State of Alaska
Department of Fish and Game
Sportfish Division

Nomination Form
Anadromous Waters Catalog

Anadromous Waters Catalog Number of Water Body 252-38-10010

Name of Water Body *Anton Slough ☐ USGS Name ☒ Local Name

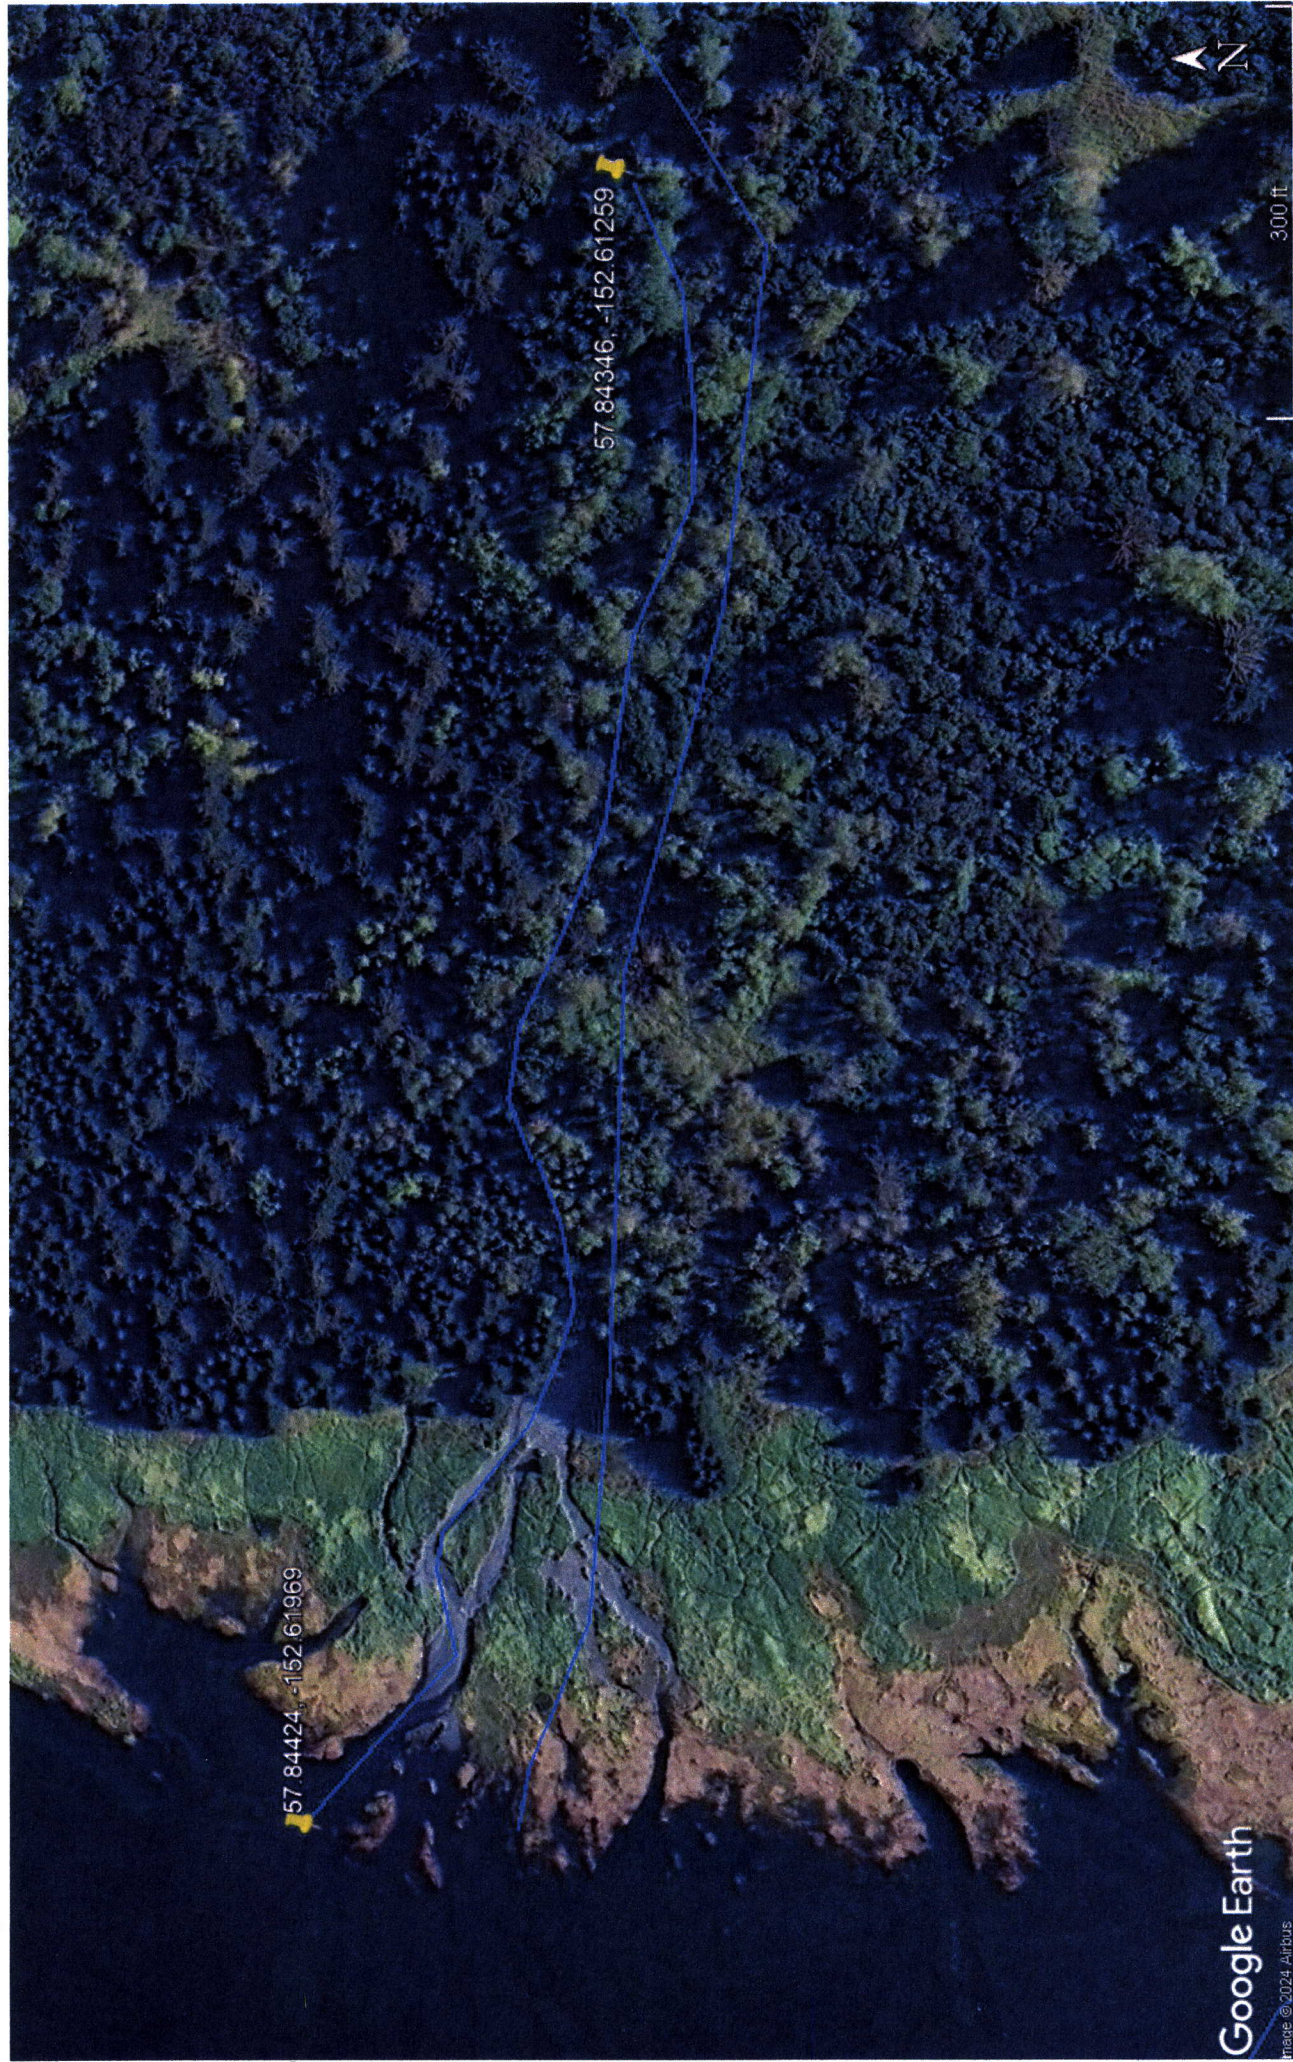
I used three baited minnow traps to attempt to capture juvenile coho salmon. I captured about 30 resident Dolly Varden and observed about 75 additional DV. No juvenile coho were captured or observed. While on site, I located the correct location of the lower 500 meters of the stream reach and outlet (Figure 1). The outlet is located at 57.84424, -152.61969. The lower 300 meters of the stream reach flowed subsurface to tidewater.

~UPDATE/ADJUST lower hydrography and stream mouth point of existing AWC Stream #252-38-10010.

Map #1

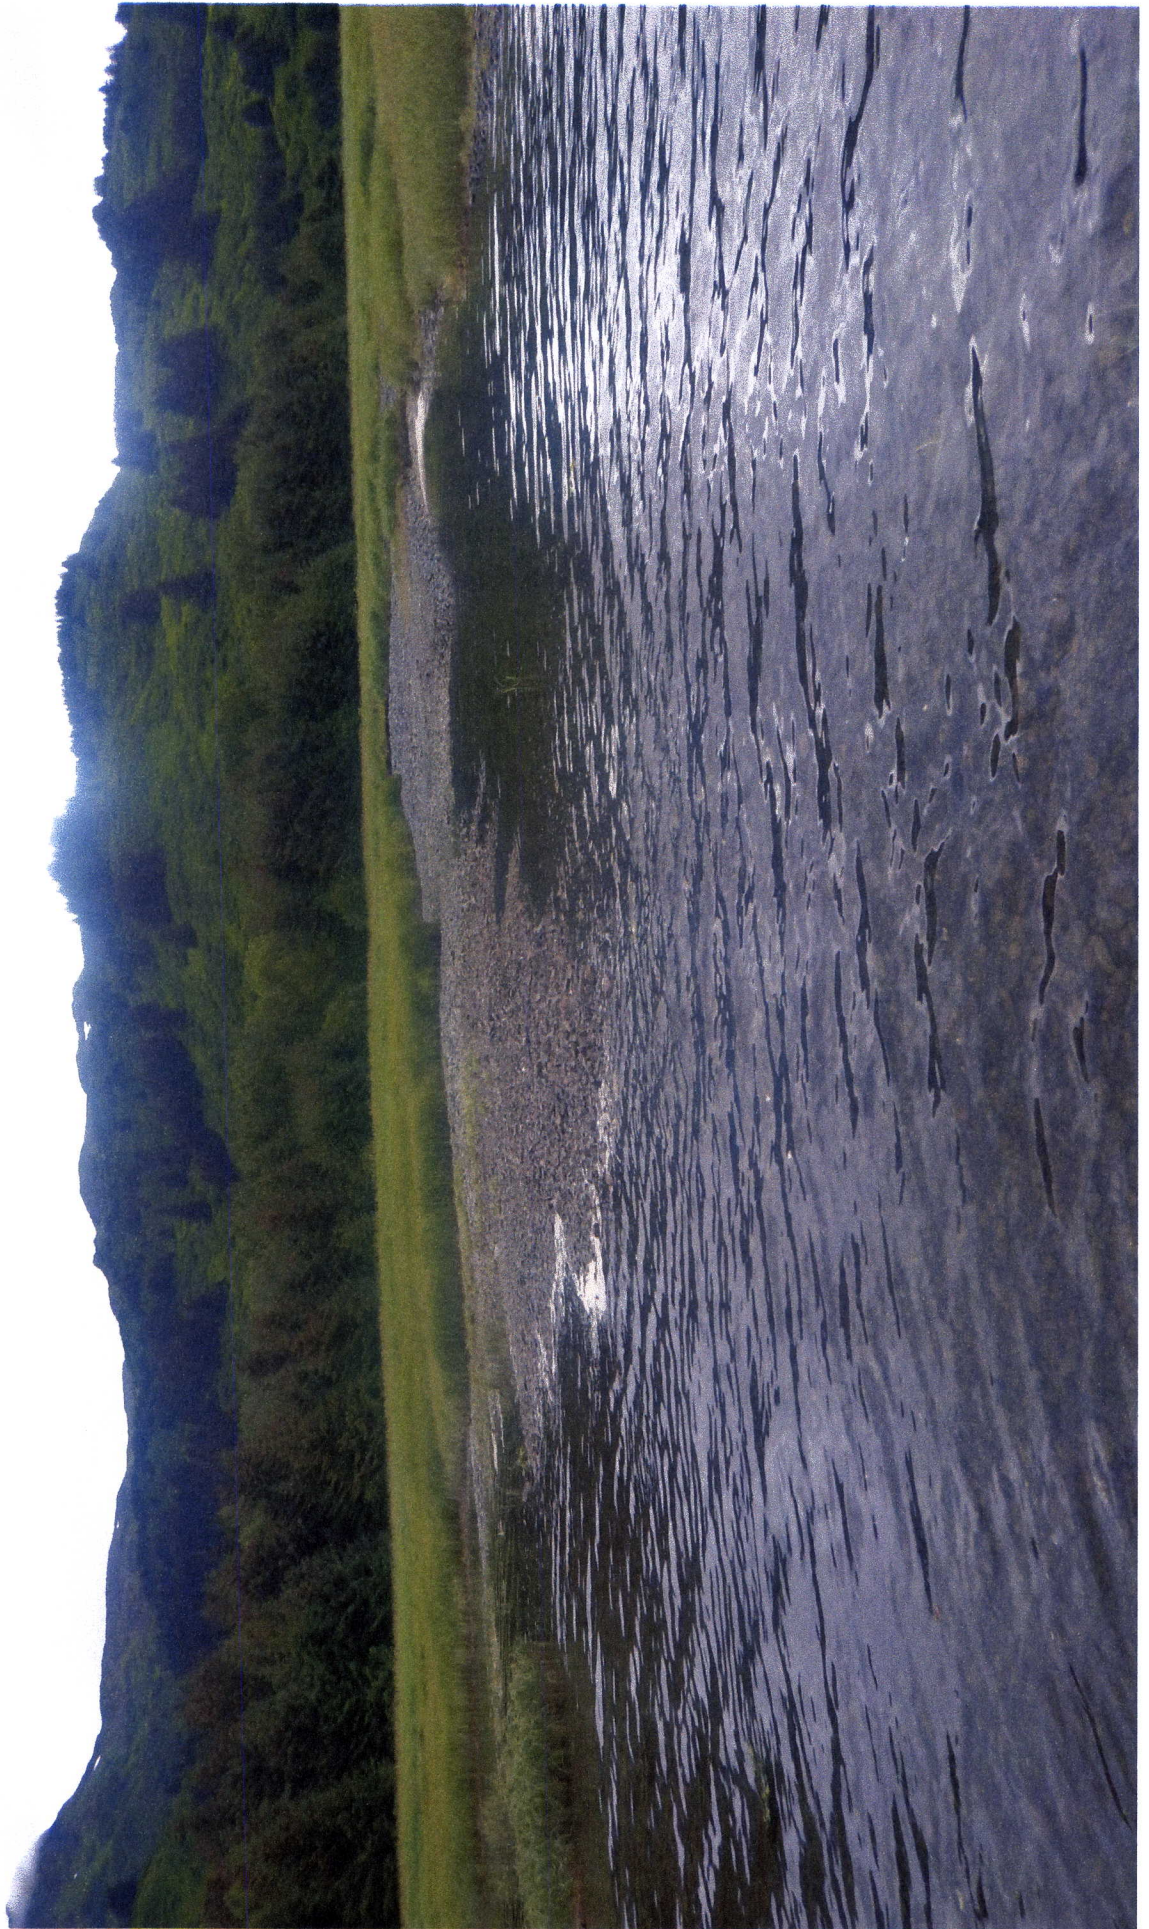
DELETE
delete
old
lower

-UPDATE/ADJUST lower hydrography and stream mouth point of existing AWC Stream #252-38-10010.
-ADD local name ""Anton Slough" to existing AWC Stream #252-38-10010 (per Nom #09-396).
-Please update using most recent .GDB with line, point, lake, polygon and barrier features located in O:\DSFIR5\AWC\Draft2025\GISData\AWC2025_WorkingUpdate_DayMonthYear.gdb
